Cosmopolitan Industries PVT Ltd (Epic) (Extension)

Khejurbagan, Baro Ashulia, Ashulia.
(23.891528, 90.323389)
03 September 2023

Observations

Crane at the beam

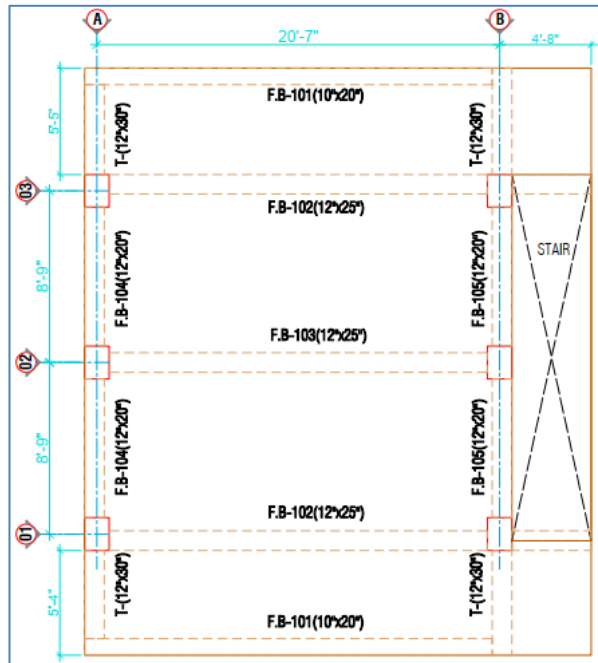
Overhang crane suspended from beam

Crane beam suspended from beam at 2nd floor level. Missing bot was observed in the connection. Building engineer is required to calculate the imposed loading and check the adequacy of floor/column/foundation and connection of the crane support. Also, install the missing bolt.

Bolt missing at connection

Item No.	Observation	Recommended Action Plan	Recommended Timeline
01	Design report required to be revised. (ETP Expansion)	Verify in-situ concrete strength taking 100 mm diameter minimum 4 cores from lower tier column.	6-weeks
02	Design report required to be revised. (ETP Expansion)	Building engineer to update the design documents based on in-situ concrete strength in compliance with BNBC-2006.	6-weeks
03	Design report required to be revised. (ETP Expansion)	Carry out remedial works if required.	6-months
04	Crane at the beam. (ETP Expansion)	Building engineer is required to calculate the imposed loading and check the adequacy of floor/column/foundation and connection of the crane support.	6-weeks
05	Crane at the beam. (ETP Expansion)	Install the missing bolt.	6-weeks

Item No.	Observation	Recommended Action Plan	Recommended Timeline
06	Crane at the beam. (ETP Expansion)	Carry out strengthening work if required.	6-months
07	Crane at the beam. (ETP Expansion)	Limit crane safe working load as required.	6-months
08	Mismatch in Design Report. (Utility Storage)	Building engineer is required revise the design report as-built beam & column layout of the structure.	6-weeks
09	Mismatch in Design Report. (Utility Storage)	Carry out remedial works if required.	6-months
10	Damages in roof beam. (Utility Storage)	Building engineer is required to repair the damage beam with a suitable method.	6-months
